Safety Chain Replacement

Bulletin Type:	Recall	Publication Date:	June 2025
Bulletin #(s):	25V-377 USA 2025-308 Canada	Make(s):	Starcraft
Job Code(s):	9902634	Model(s):	Autumn Ridge TT
Flat Rate(s):	9902634 .50 HR Safety Chain Replacement	Model Year(s):	2025

SAFETY CHAIN REPLACEMENT INSTRUCTION

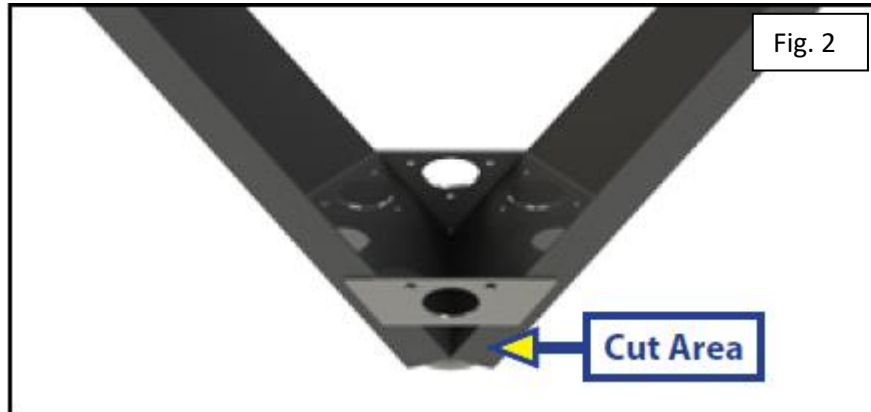
1. Use the die grinder with the cutting wheel attachment to remove the existing chain elbow from the underside of the A-frame coupler (Fig. 1).
2. The existing safety chains can be set aside with the chain elbow.

3. Use the die grinder and grinding wheel attachment to grind the cut areas smooth (Fig. 2).

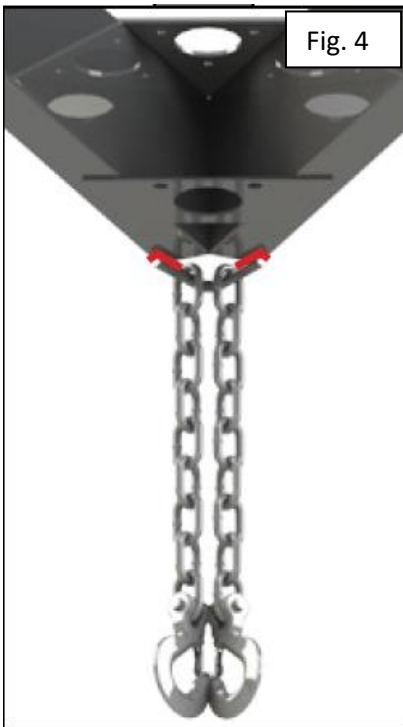
4. Feed the last link of each of the new safety chains onto the new chain elbow (Fig. 3).
5. Center the chain elbow and safety chain assembly under the A-frame coupler so that the ends of the chain elbow are touching the ends of the two A-frame tubes. The elbow should be pointing away from the trailer.
 - a. Note: Ensure that the new safety chains are not pinched between the chain elbow and the coupler. The safety chains MUST be able to move freely.
6. Weld each end of the chain elbow to the A-frame tubes completely (Fig. 4 and 5).
7. Test the movement ability of the safety chains to make sure they are able to move freely.
8. Spray paint any visible areas of the repair with black spray paint.
